Doc or ECO #:	ECO-70683-002	Date:	05/07/19	Author:	SCL
	Rev. #:	A				
Engineering Change Order (ECO)	Engineering Approval:	Aeg	Date:	5/07/19	Quality Approval	DO

P/N #:	70683	Effective Date:	May 9, 2019
Title:	Ruggedized MSS Power Supply Capacitor Reverse Modification

Figure 1 Power module with Capacitor highlighted.

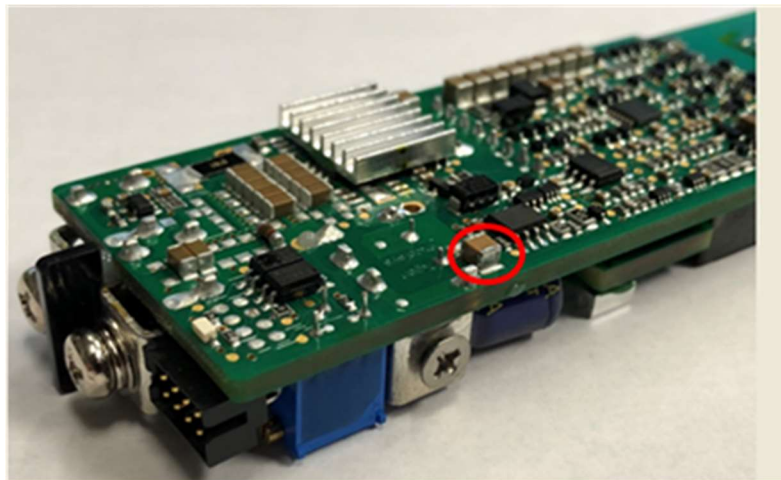
MSS power supplies previously had an ac coupling capacitor removed to reduce leakage that was causing GFCI's to trip (ECO-70683-001)

The removal of this capacitor had the side effect of degrading the the connection quality on our m100 communications modem. Replacing this capacitor allows the m100 to function correctly and at full performance. In a previous ECO GFCI's were replaced with ELCI's, which will prevent the circuit tripping from returning.

Arrow/Excelsys provided the specifications of the AC coupling capacitor.

(72006 - CAP CER 0.1UF 500V X7R 1210 - Digikey - 399-6478-1-ND)

Engineering replaced the removed capacitor and retested the system. All communication issues were resolved, signal strength was strong (determined by the green status LED on the m100 modem signifying 80+mb/s, and the TX_DT was averaging 26ms.

It was determined that the capacitor will be replaced moving forward.

The IP65 power supply chassis (52347) will also come with the AC coupling caps installed.
